SUBJECT: Forwards supplemental info re implementation of AMSAC sys.

H. B. ROBINSON STEAM ELECTRIC PLANT, UNIT NO. 2
DOCKET NO. 50-261/LICENSE NO. DPR-23
SUPPLEMENTAL PLANT-SPECIFIC AMSAC INFORMATION

ATTACHMENT 1

HBR AMSAC FUNCTIONAL DIAGRAM

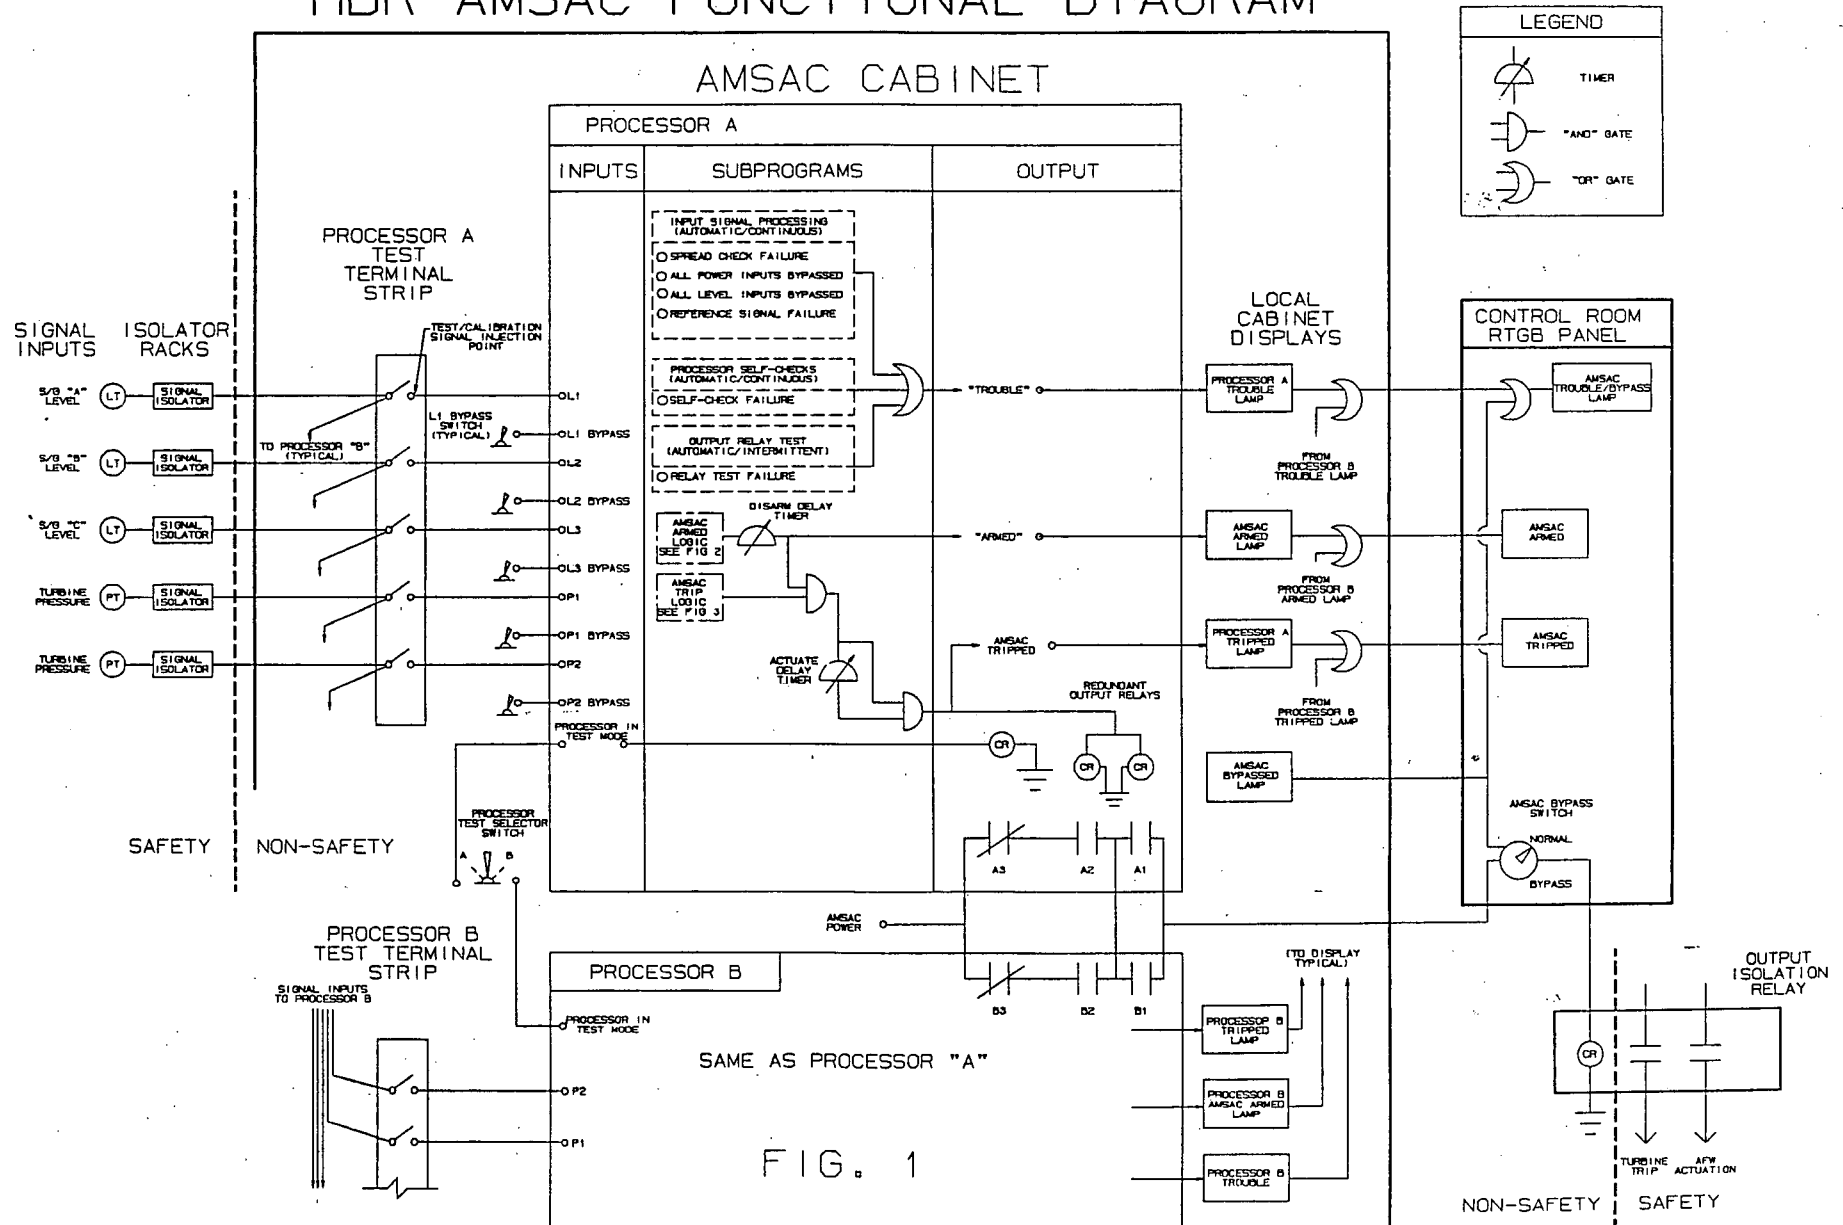
Provide a simplified Logic Diagram.

RESPONSE: The CP&L AMSAC system utilizes the capabilities of a pair of redundant microprocessors in a moderately sophisticated scheme in order to enhance system operability and reliability. As a result, the system does not lend itself to the type of simplified logic diagrams typically depicted in the AMSAC WCAPs. However, in order to facilitate the staff's review, a simplified Functional Diagram (Figure 1) has been attached to provide an overall view of the AMSAC system from its interface with the existing plant input signal to its interface with the output actuation circuitry. To maintain the simplicity of the diagram, the more relevant functions of the microprocessors have been depicted as subprograms, the outputs of which feed the overall program logic. The detailed operations of these subprograms have been provided on separate figures (Figures 2 and 3). Although all of the functions and capabilities of the system are not depicted by the diagram, CP&L believes that the attached figures provide the level of detail required for the NRC to perform its review.

The information concerning testing capabilities (Section 12) provides a discussion of the system capabilities which will help explain the Functional Diagram.

AMSAC LOCAL PANEL

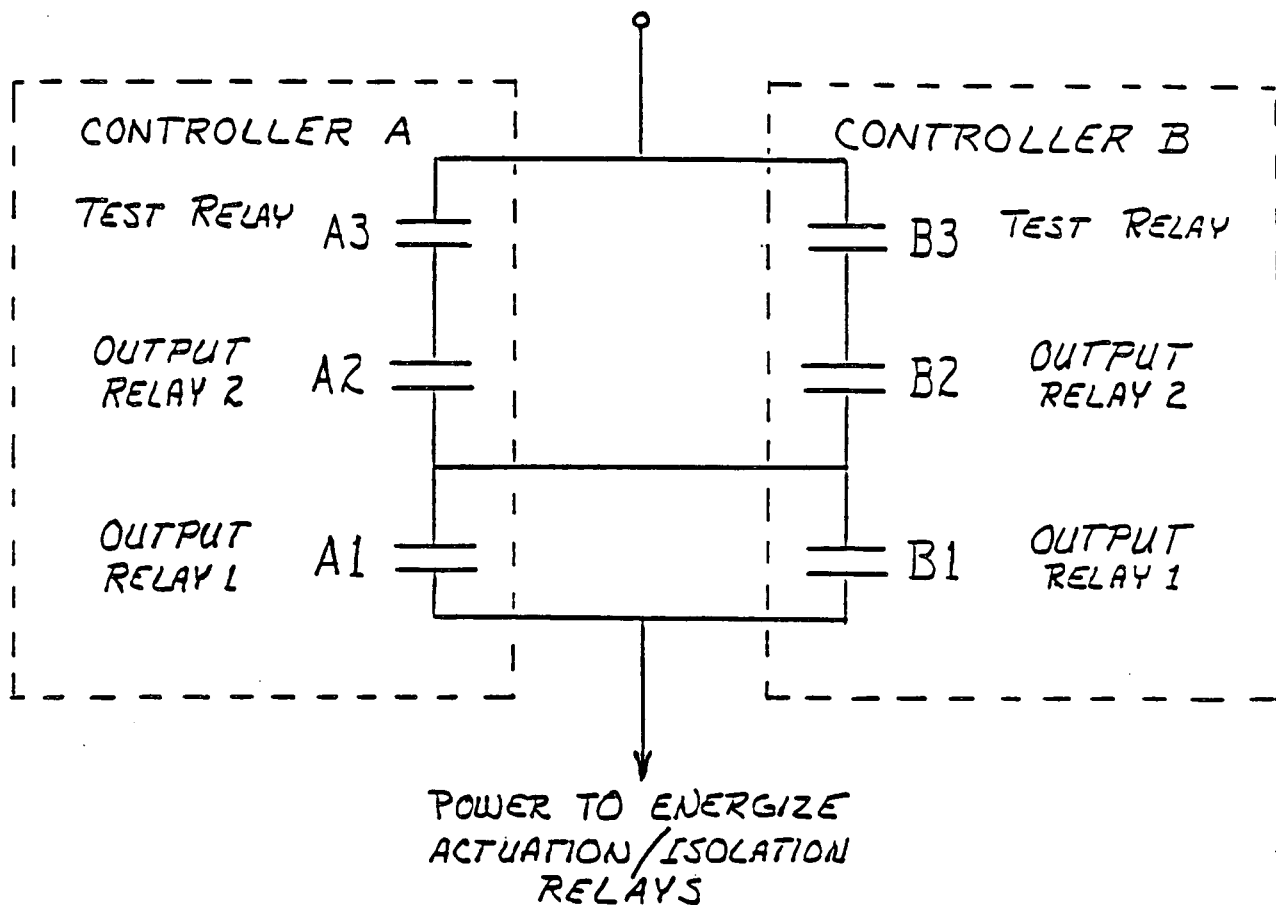
Bypass Switch Location

RESPONSE: As identified during the course of the subject conference call, a bypass switch will not be provided at the local AMSAC panel as shown in Figure B of the original submittal. This switch is provided in the Control Room only.

The AMSAC controller program will perform a "spread check" on AMSAC input signals every scan cycle and light the "AMSAC Trouble" lamp on the RTGB in the Control Room and on the local AMSAC panel if a large difference exists among the signal inputs from the steam generators or the turbine. The plant personnel will then use the AMSAC panels diagnostic features to investigate the nature of the problem. The spread checks test each signal for most failure modes, however, slight instrument drift cannot be detected. These will be adjusted by the refueling outage calibrations. Figure 4 shows the controls and displays currently planned for this local AMSAC panel. The final design may be subject to change.
